2.3 PROBLEM

DRAWINGS AND DOCUMENTS PROVIDED FOR AUDIT

Land South and East of
Adastral Park, Ipswich

Off-site Highway Mitigation:
Adastral Park Roundabout
and Gloster Road Mitigation

Indicative Junction Layout
Scale: 1:500

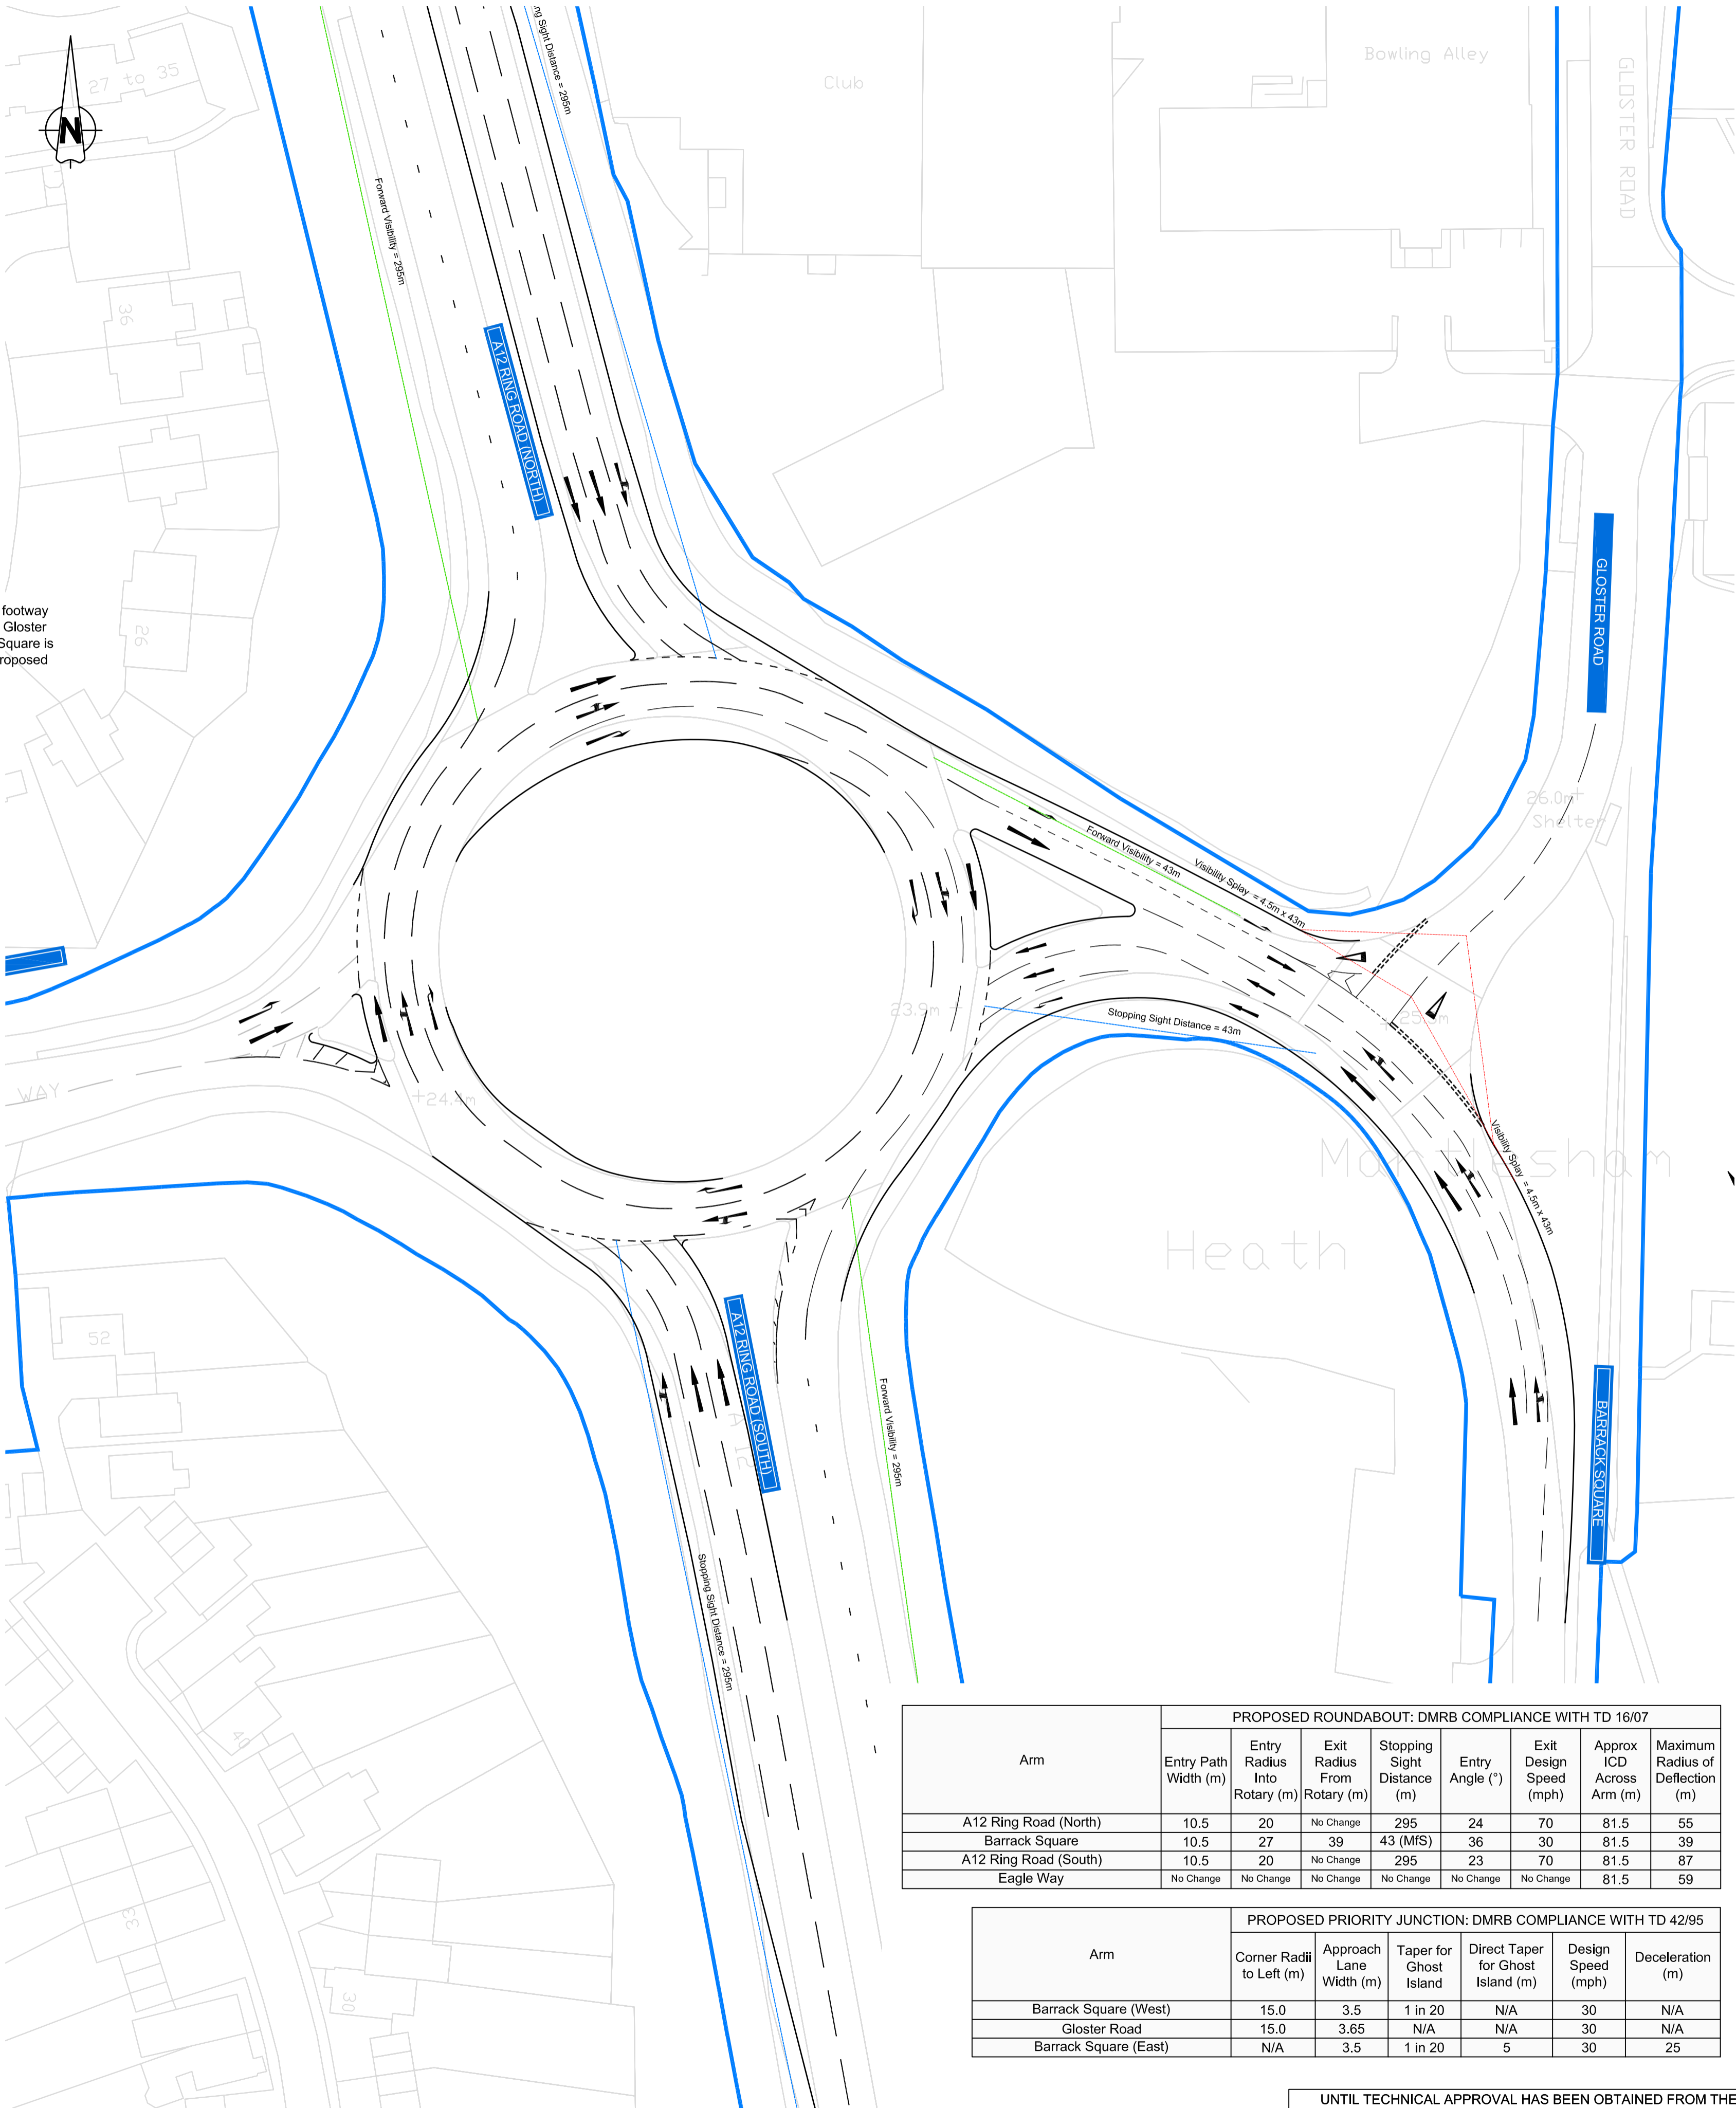
Location: Southeast and southwest quadrant of circulatory carriageway.

Summary: Risk of sideswipe accidents.

The layout indicates a very narrow centre lane on the southeast quadrant and a risk of the nearside lane not being wide enough for the radius required to be traversed on the southwest quadrant from the A12 southern arm.

Carry out swept path analysis to ensure that all vehicles can travel within the intended lanes and make adjustments as required.
